LEVEL 2 — OVERALL FLOOR PLAN (REV G)

PROJECT Hazel Green Regional Athletic Complex Trojan Horse Arena · Hazel Green area, Madison County, Alabama (site TBD, D-006)	PHASE PHASE 2	SHEET TITLE OVERALL FLOOR PLAN LEVEL 2 · BLOCK PLAN	SCALE 1" = 40'-0"	DATE October 2026	REV G	DRAWN BY Drawn by Claude (AI) for Shane Brazelton	SHEET P2-A-102
--	-------------------------	---	---------------------------------------	---------------------------------------	-----------------	---	------------------------------

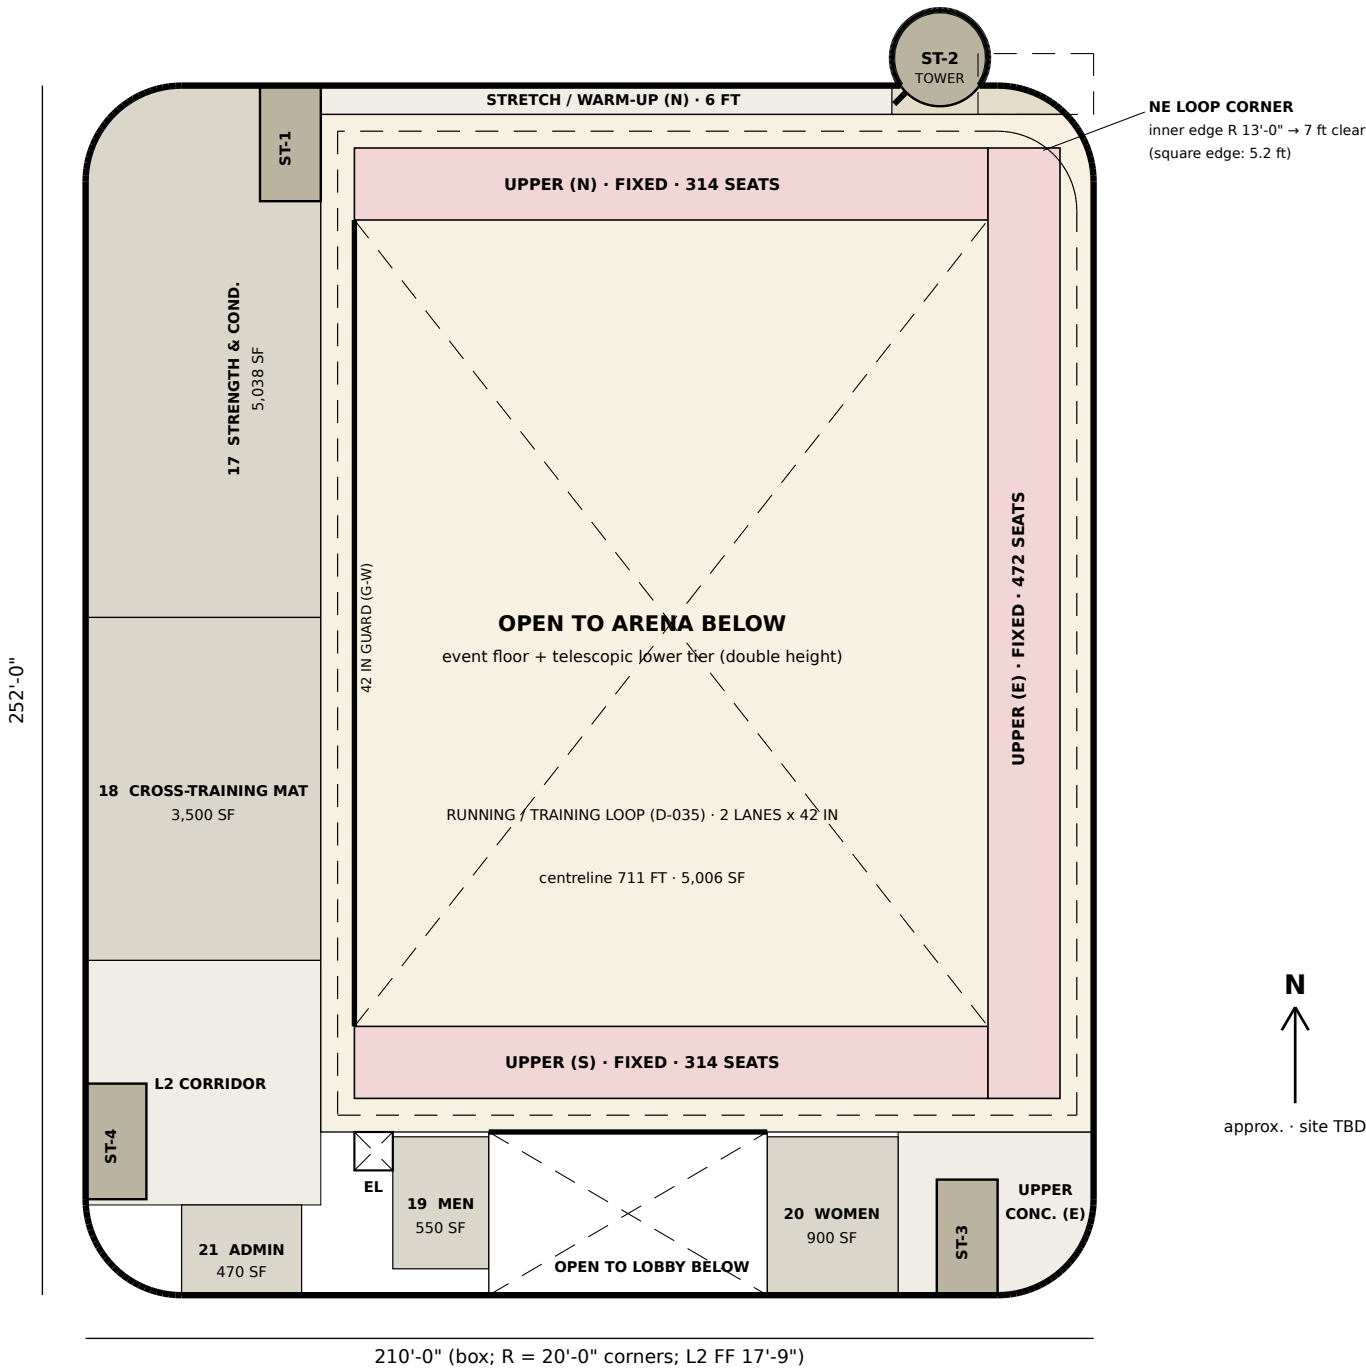
CHANGES FROM REV F (all ASSUMED)

- Envelope: box with R = 20 ft corners; S&C (17) and the L2 corridor lose the NW / SW corner area; upper concourse (E) loses the SE corner.
- ST-2 is the 20 ft cylindrical tower (centre 178, 257.7). It replaces the 24.08 x 12.67 ft NE stair, so the north stretch strip now ends at x 168 and the tower is entered from the strip by a door on its SW face (no L2 door on the loop).
- ST-3 and ST-4 as Rev K (slid along their walls); same L2 position as L1, rooms trimmed around them.
- NE loop corner: the 20 ft arc cuts the loop's outer corner; with a square inner edge the clear width drops to 5.2 ft (7 ft = 2 lanes x 42 in needed). Inner edge rounded to R 13 ft keeps 7 ft; the tier corner loses 4.6 SF (under 1 seat).
